Addendum No. 1

Subject: Franklin S. Edmonds Elementary School Major HVAC Renovation

This Addendum, dated June 10, 2021, shall modify and become part of the Bid Documents. Any items not mentioned herein, or affected by, shall remain strictly in accordance with the original document, as modified by addenda, if any.

4 LANDSCAPING PLAN

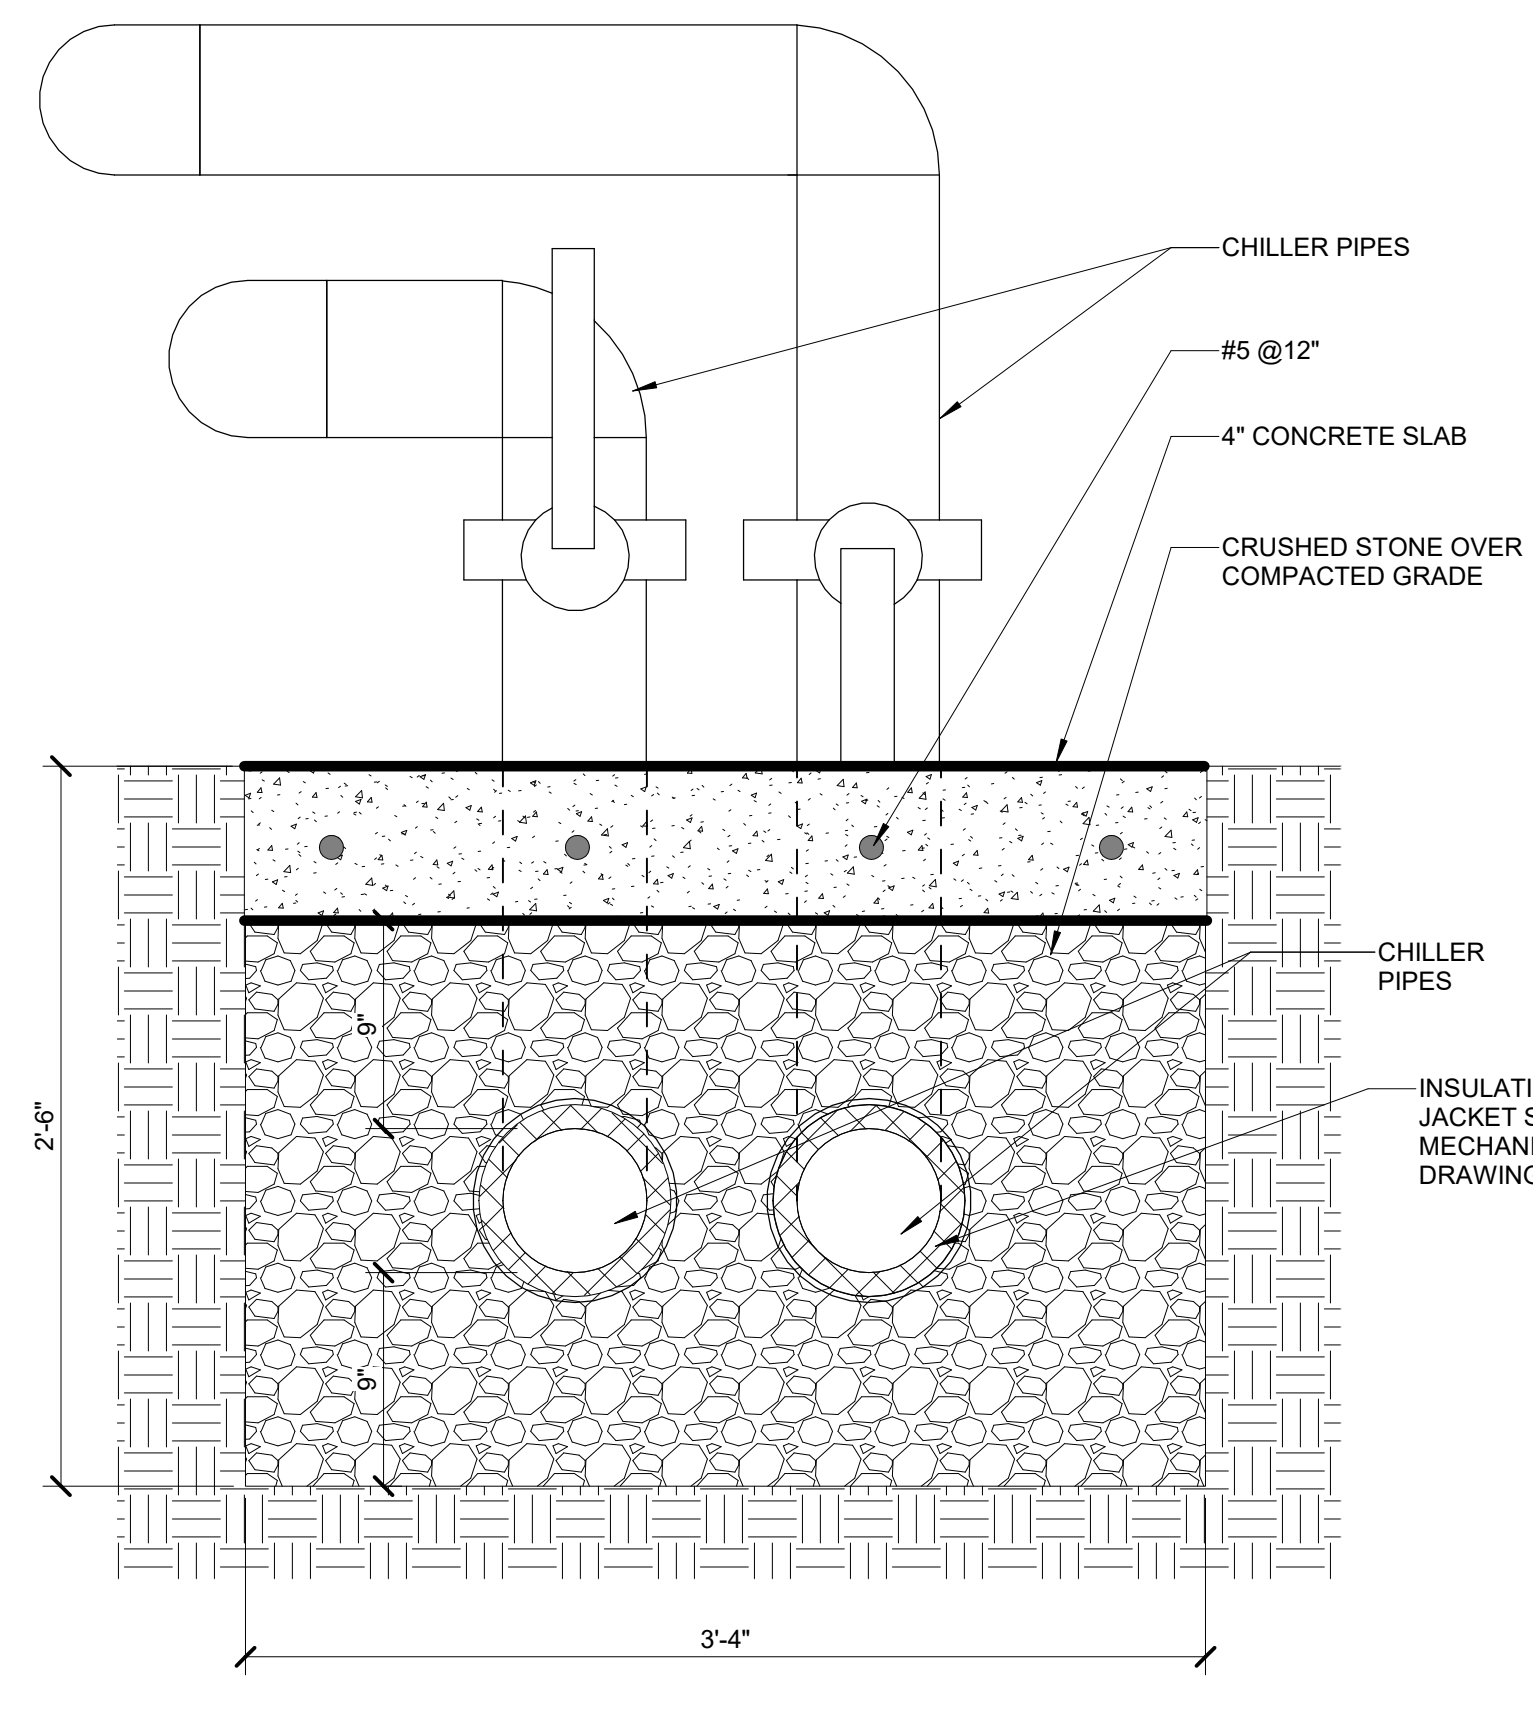
16. **ADD** Typ. Fence Elevation and Landscaping Plan to A-501. See attached.

10 FENCE FOOTING DETAIL

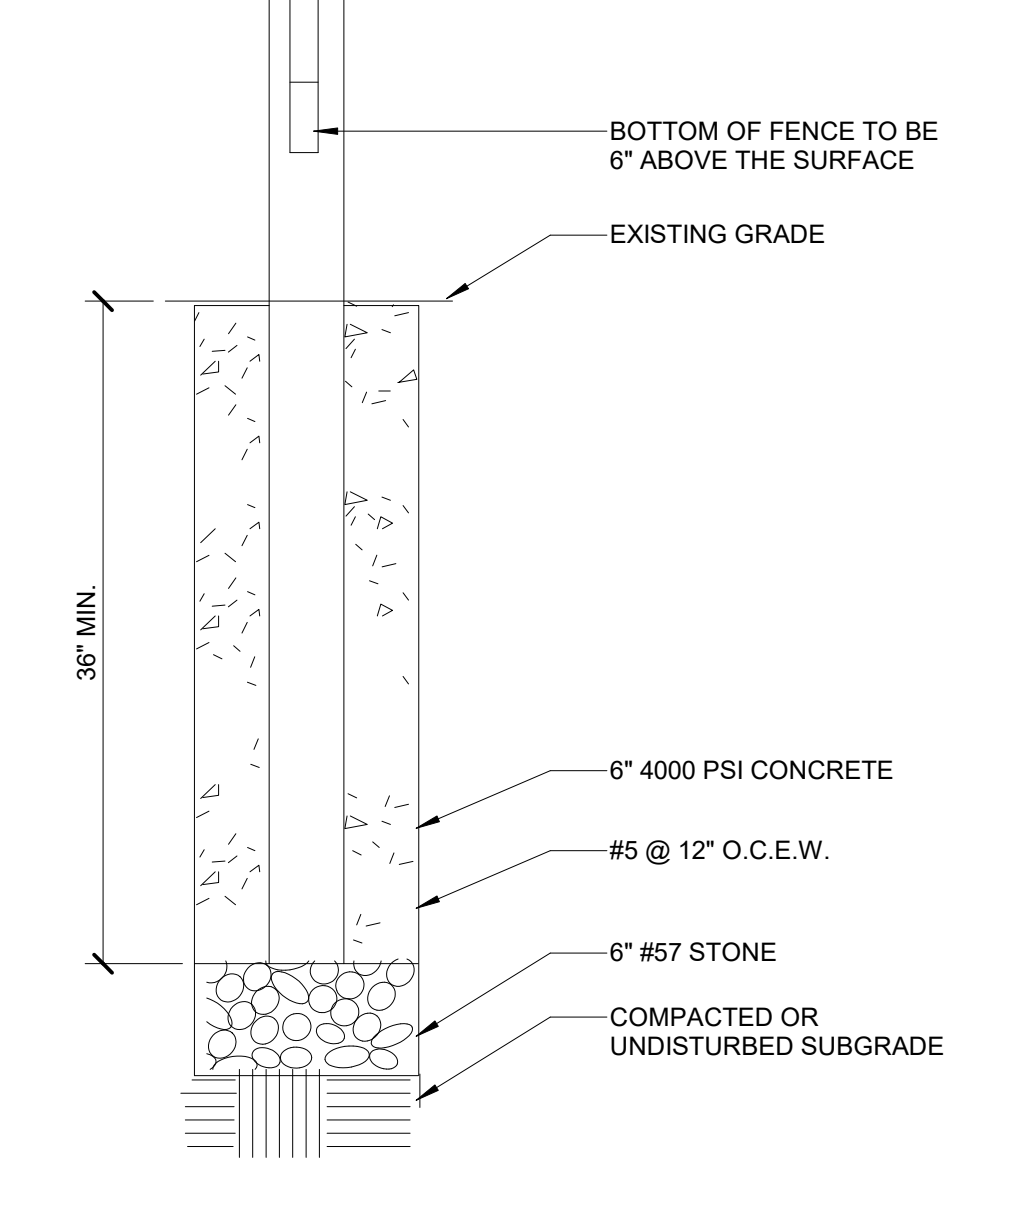
Please provide a spec and details for the fencing at the transformer.

Refer to attached updated drawings, as well as 4/A-101 for the plan and 10/A-501 for the footing detail.

EP-103

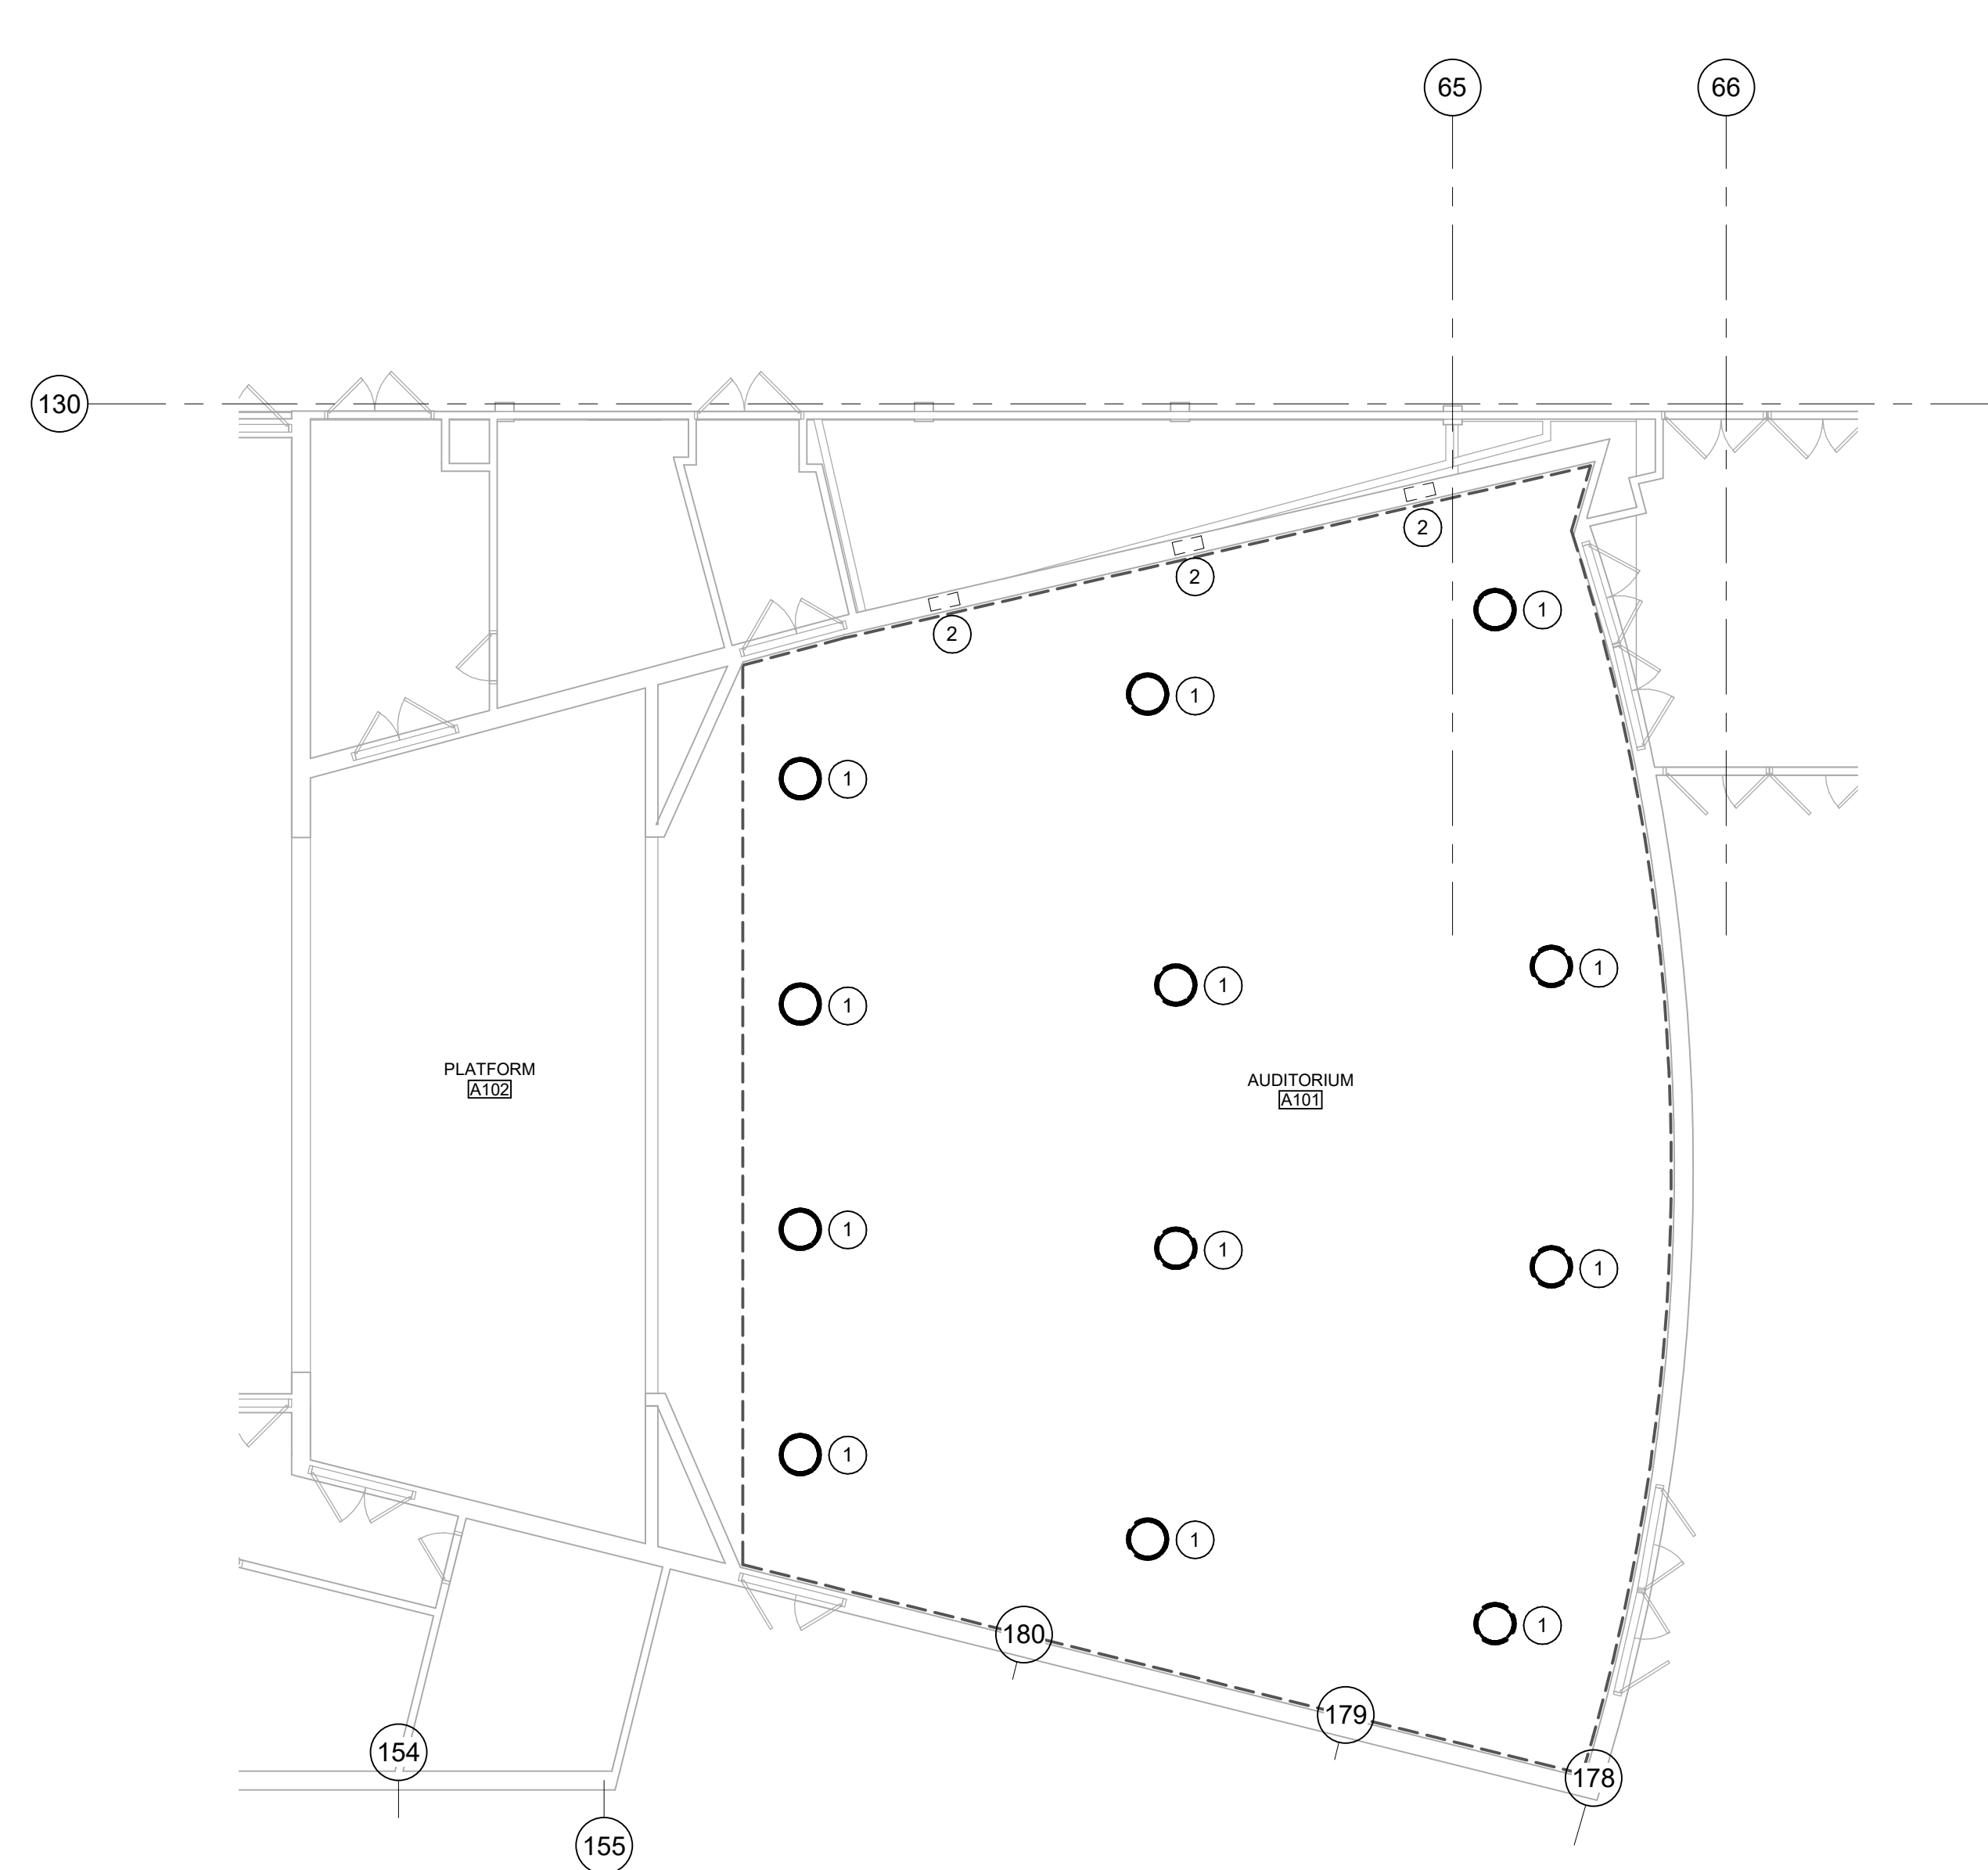
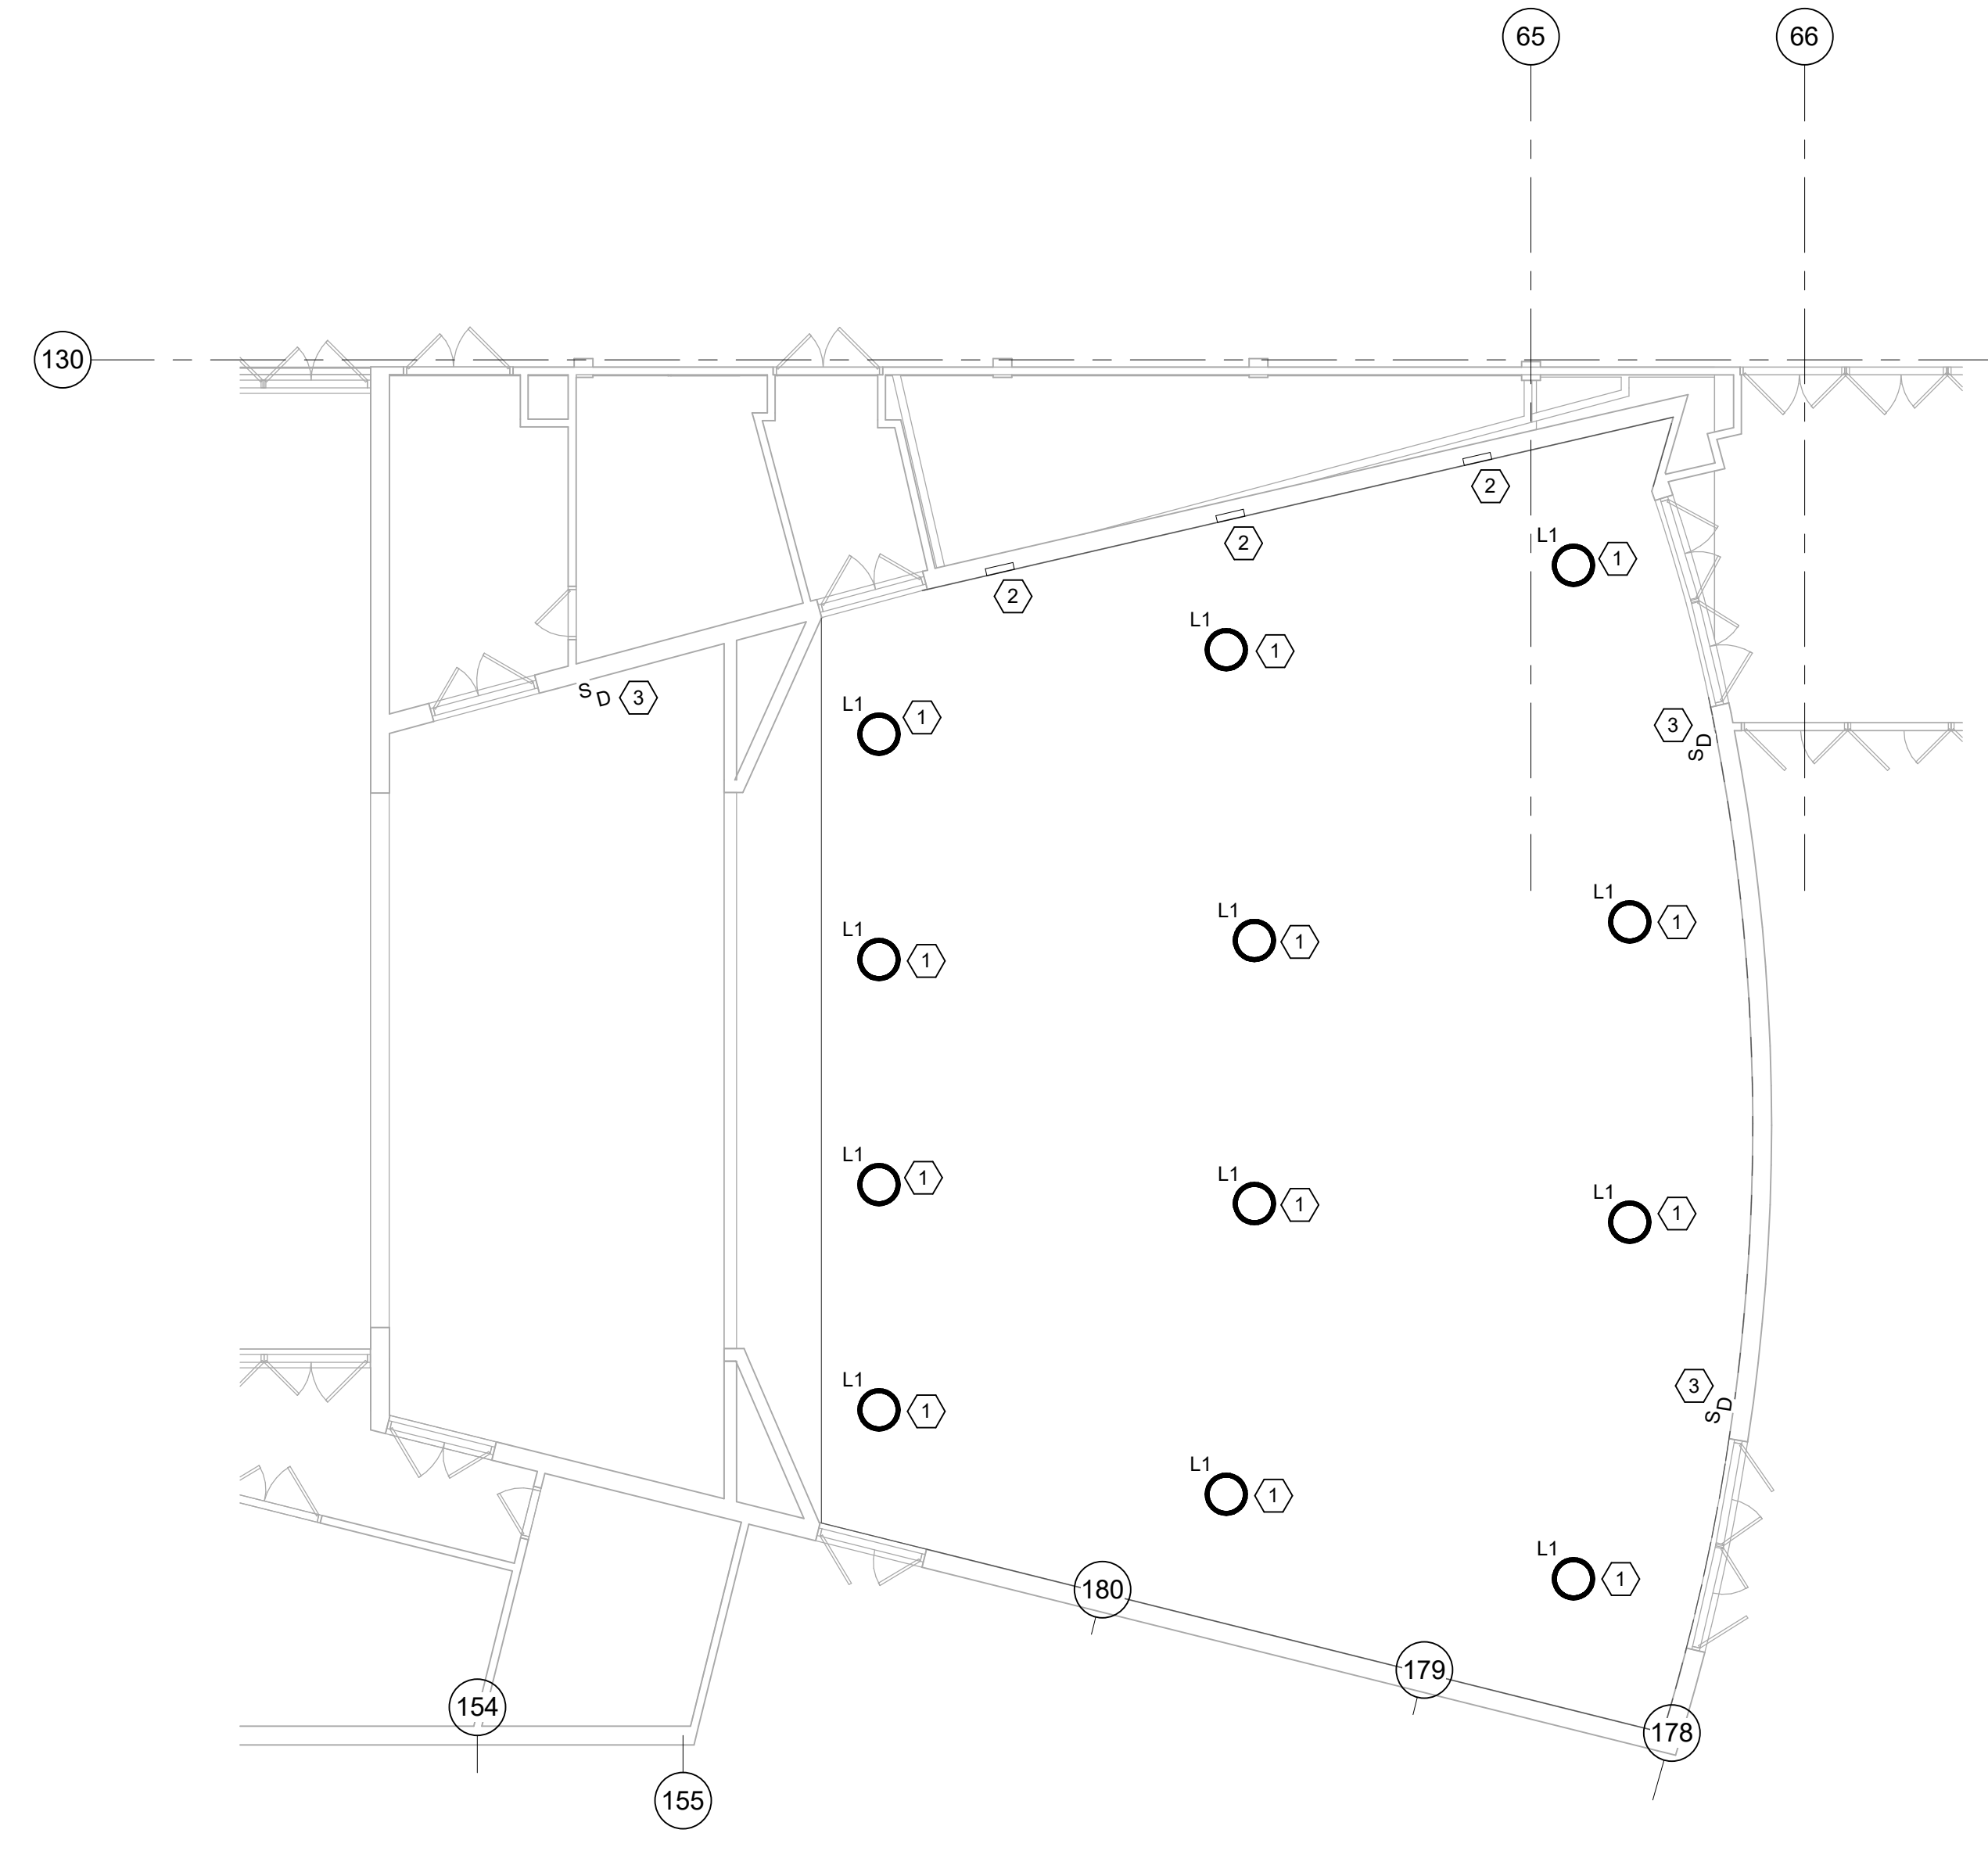
Who is responsible for electric work shown on Drawing A401 and AD401. None of this work is shown on "E" Drawings.

1. **ADD EP-103 ELECTRICAL CEILING PLANS** to define the auditorium lighting scope. See attached.
2. **MODIFY** all drawings to indicate a total of “53” Sheets. Renumber sheets 43 through 52 as 44 through 53.

Electrical Contractor is responsible for demolition of existing and providing of new auditorium lighting, wiring, conduits, controls, hangers, and accessories. Refer to attached EP-103. Corridor 123 lighting is existing to remain.
